EGG-SSDC-5288

HUMAN FACTORS ENGINEERING EVALUATION OF  
THE ADVANCED TEST REACTOR CONTROL ROOM

M. P. Boone  
W. W. Banks

Figure 18. Safety rod meter. (The convex meter face causes glare.)

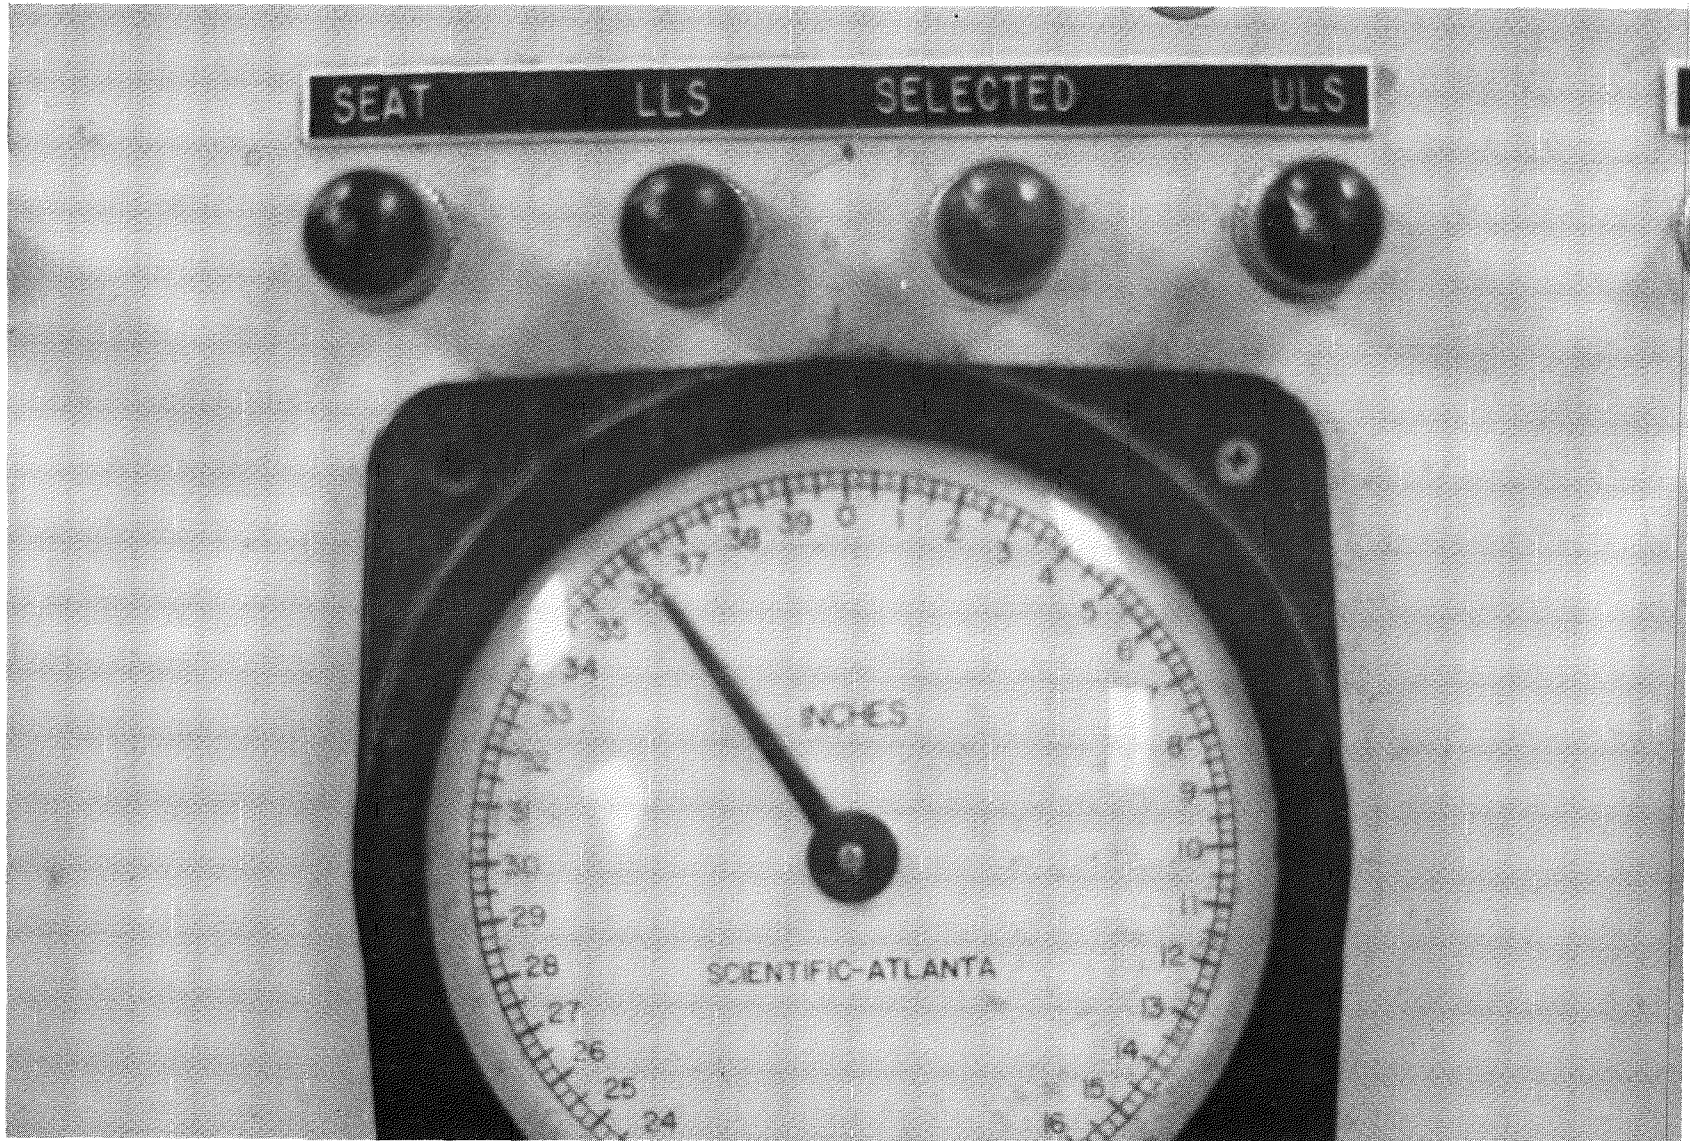
Repetitive and inconsistent labeling practices were found. It is recommended that one "general" label for each delineated system be used with each element in the system labeled for component specificity (see Figure 18).

The safety-rod meters have convex face covers which increase or contribute to overhead glare on the meter face (Figure 18). It is recommended that these displays be either (a) canted inboard toward the operator, (b) shielded, (c) a nonconvex or concave lens face be used, or (d) dull finish lens face be used.

Figure 19. Neck shim rod indicators. (Note the missing numbers.)

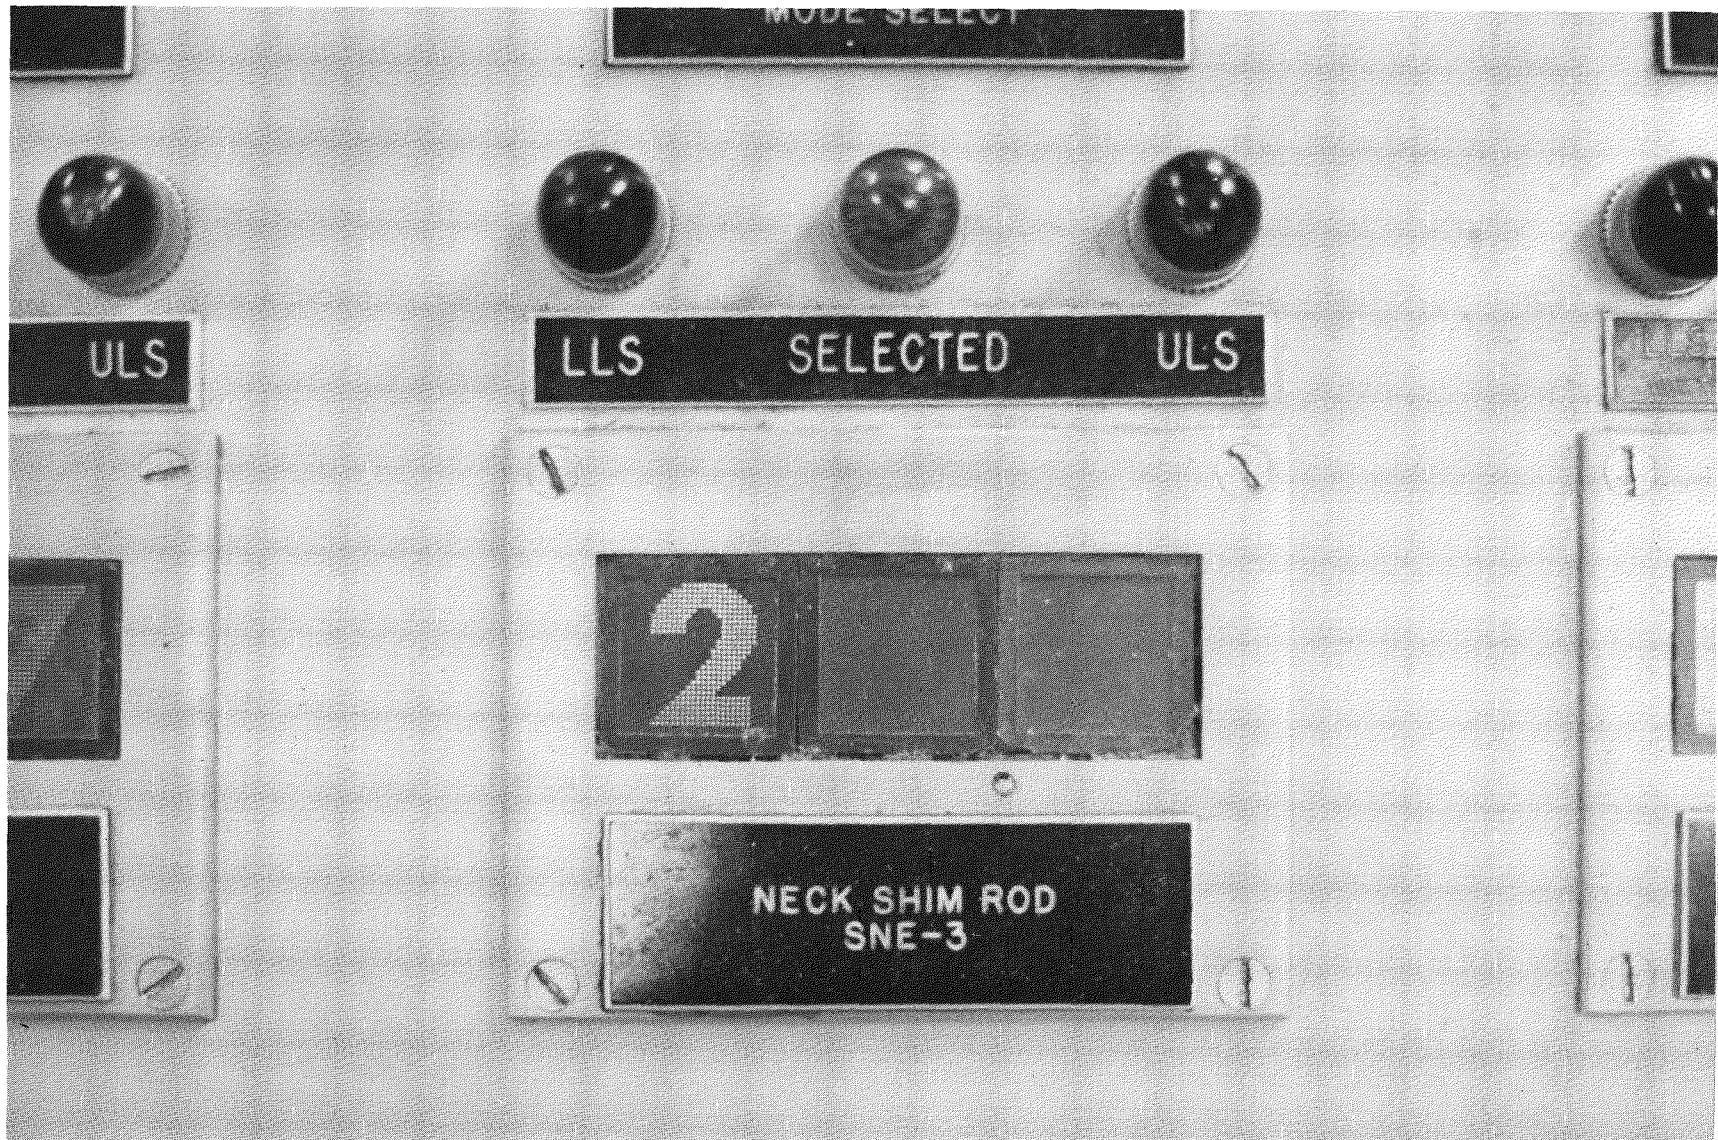
Since the numeric data displayed in inches on the neck shim meters is often inaccurate, has missing numbers, and is hard to detect (see Figure 19) due to low contrast luminance ratios, these meters should be either (a) replaced, or (b) eliminated. We discovered that only "direction" of shim movement and "relative" location/position of shims is important to operators. If this is the actual case, then numeric information is unnecessary and should be eliminated.

Figure 20. Broken neck shim cylinder select switch.

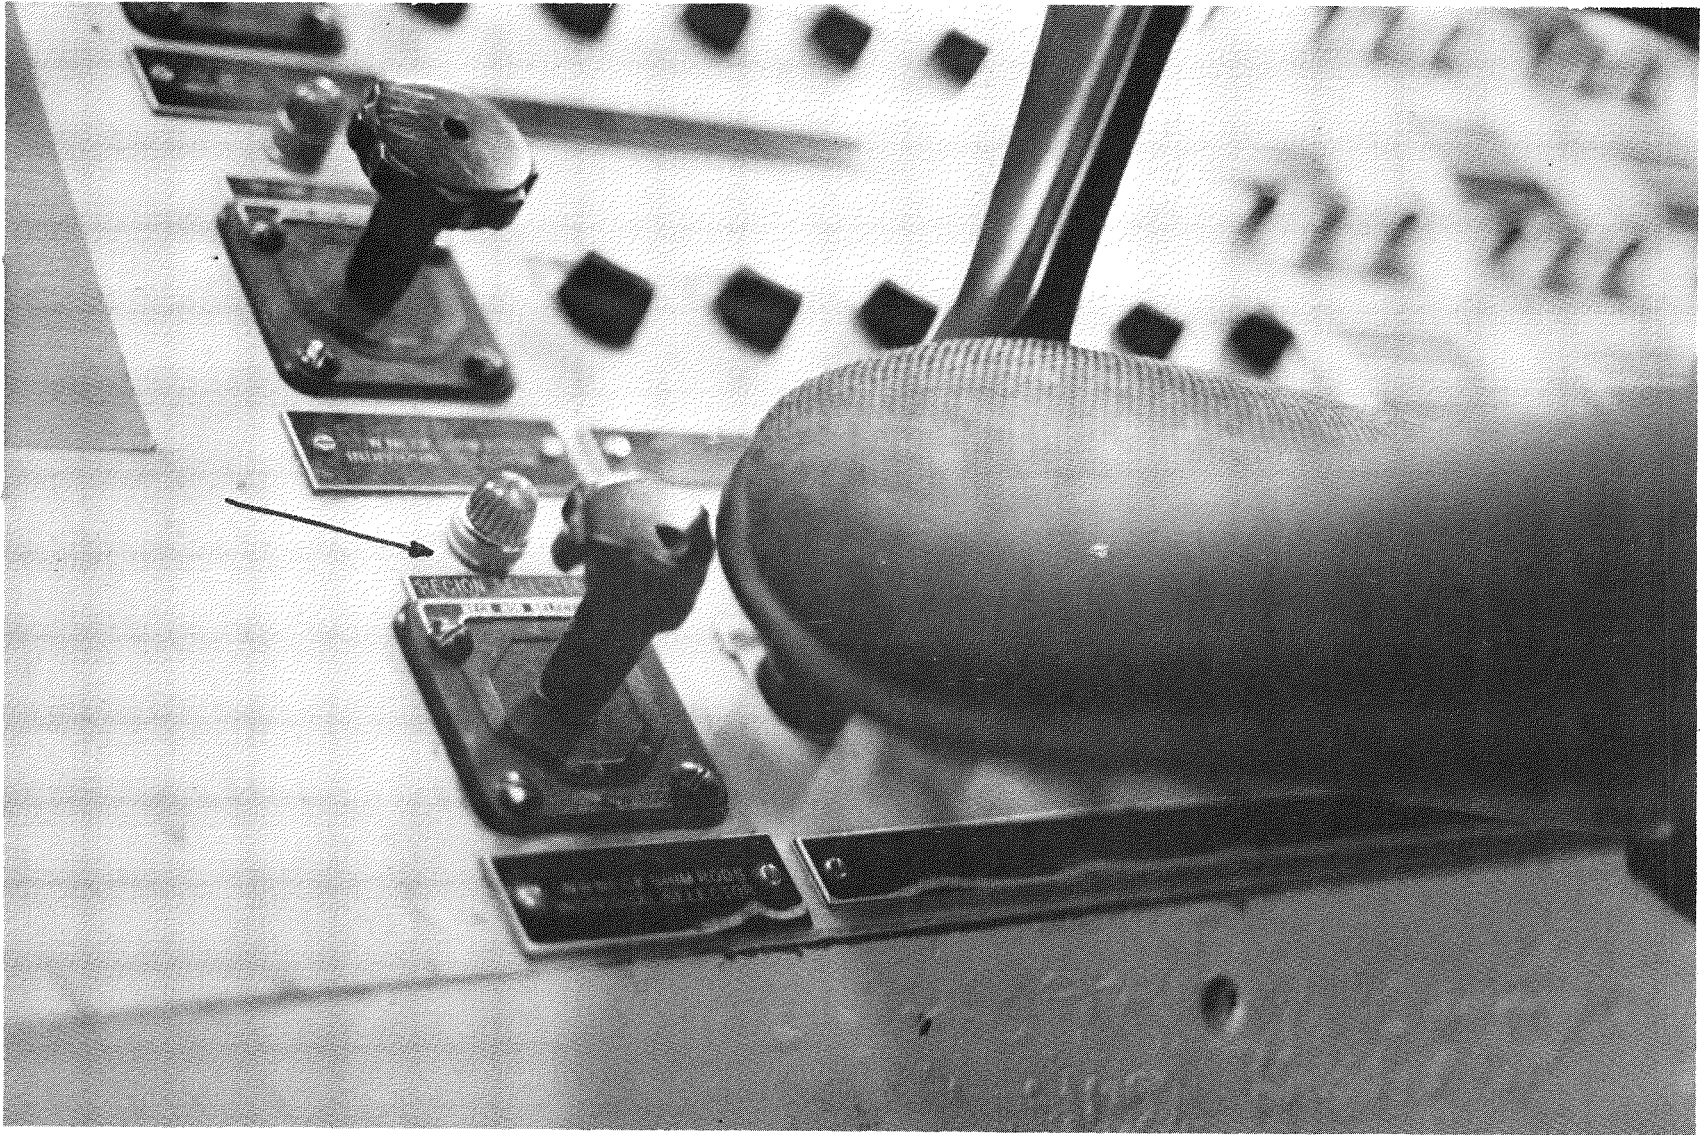
Damaged Equipment. Numerous pointers on controls were found to be broken, e.g., Neck Shim Rod Region Select. Parts should be replaced or new controls installed with sturdier pointers. One region select switch is located at the same height as the operator's chair and as a result, has been broken by the chair moving against it (see Figure 20).

Figure 21. Hand-labeled indicator lights.

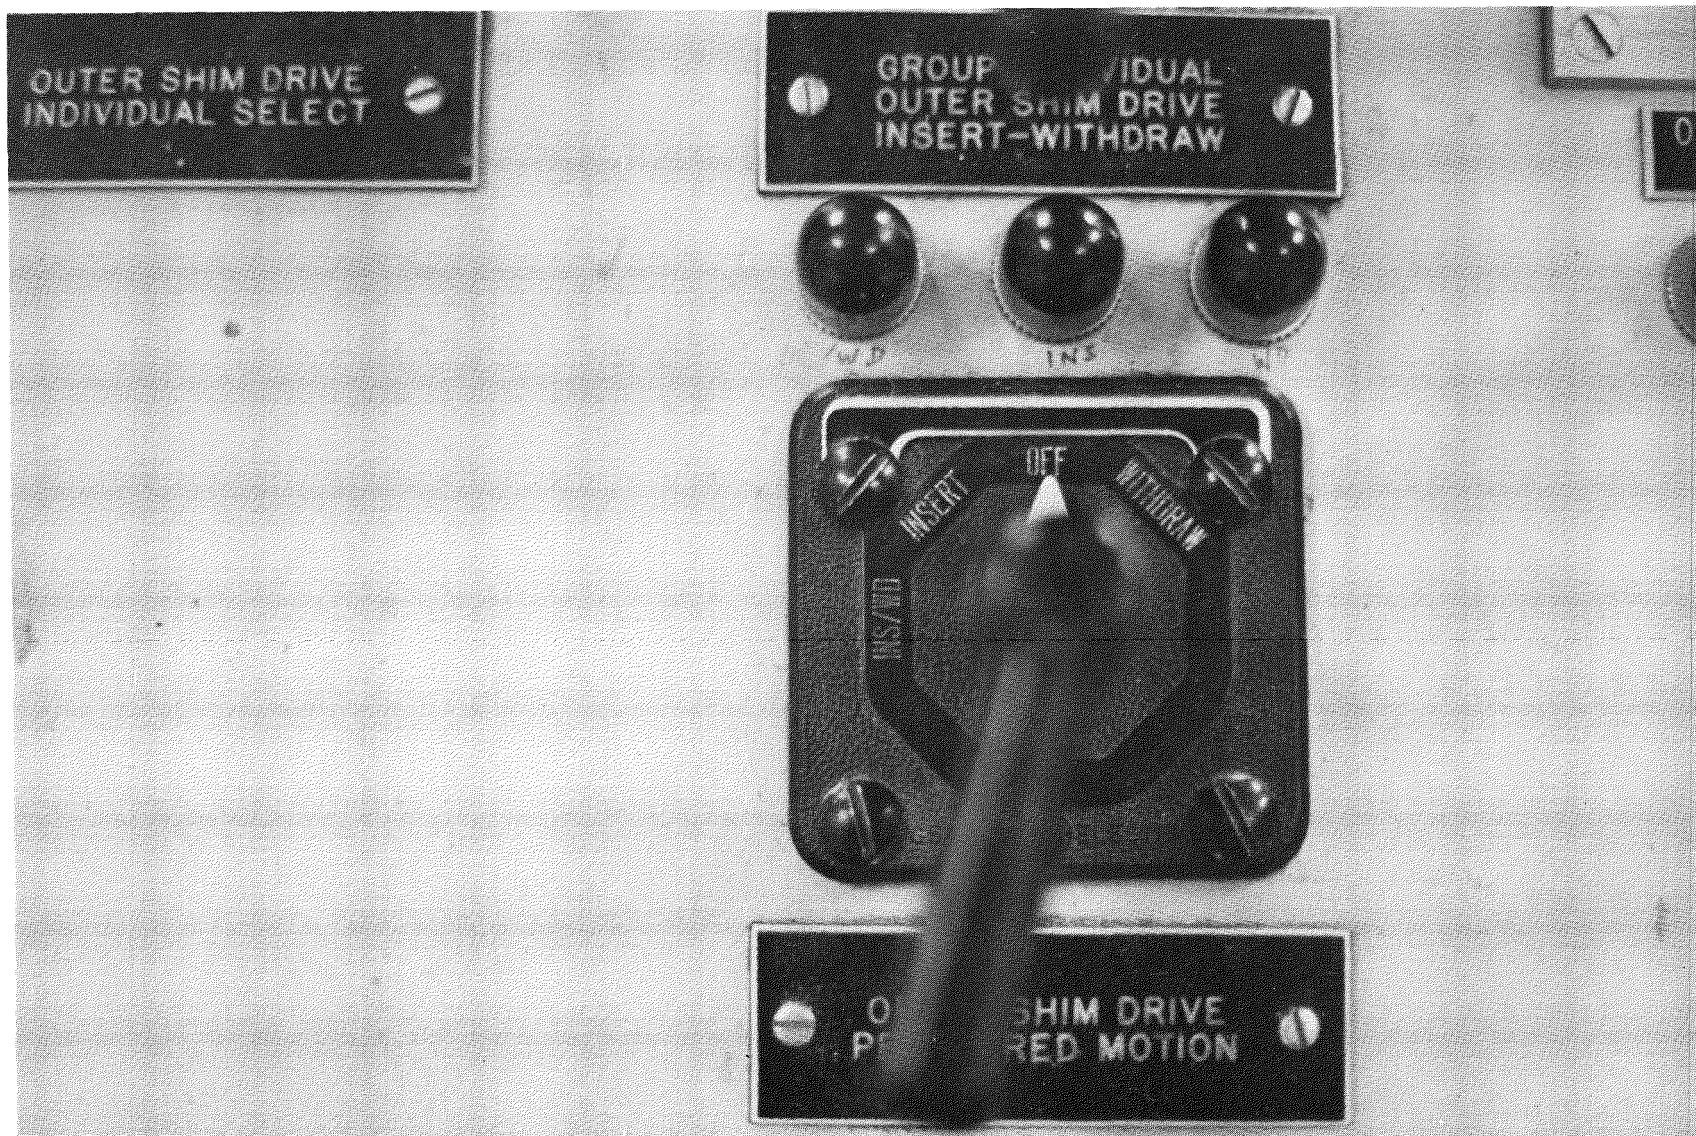
Handwritten numbers with poor legibility were found on instruments. We recommend the handwritten labels be replaced with clear, concise labeling, considering size of alpha-numerics, contrast ratios, etc. (see Figure 21).

Figure 23. Manual scram switches.

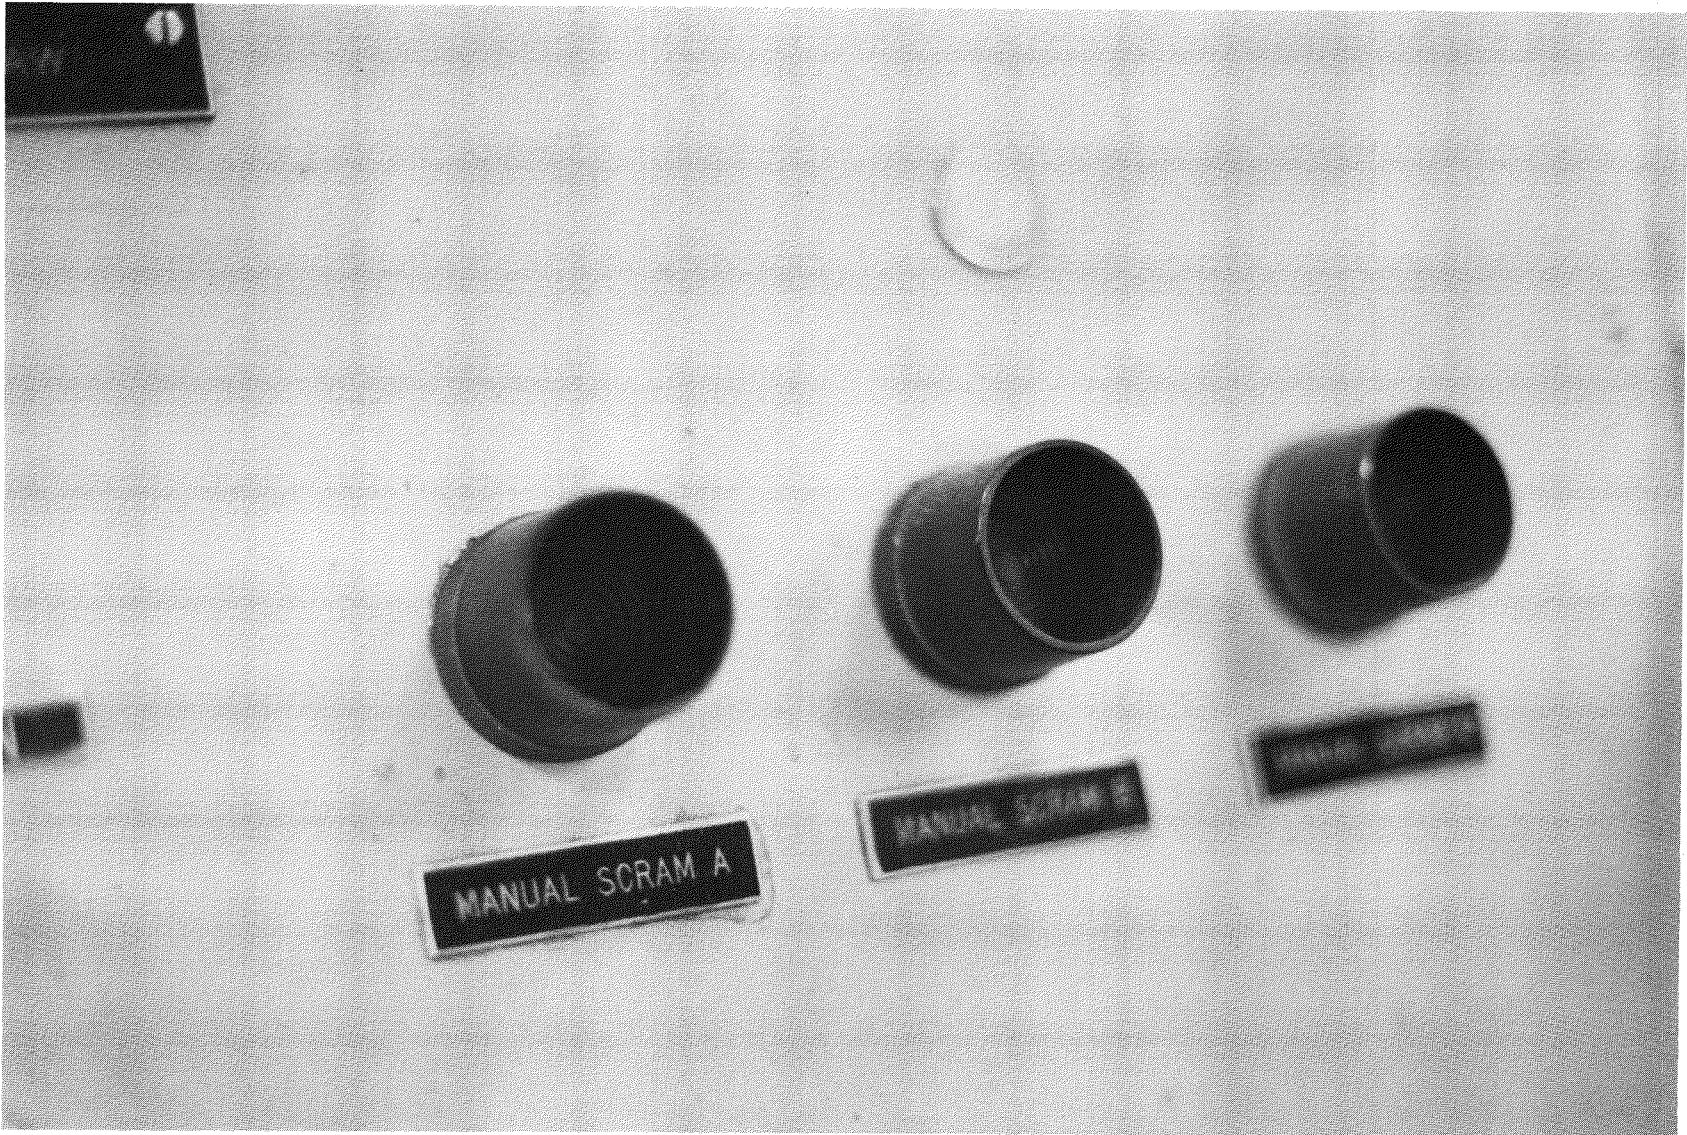
The protective covers on the manual scram switches could act as a catch basin for anything inadvertently dropped over the console. If something were dropped onto the manual scram switch, the object would be difficult to retrieve without scrambling the plant. We recommend a spring-return toggle switch (with a rounded or non-flat surfaced plexiglass hood) as an alternative manual scram switch (see Figure 23). The time required to activate the manual scram switch should be kept to a minimum.
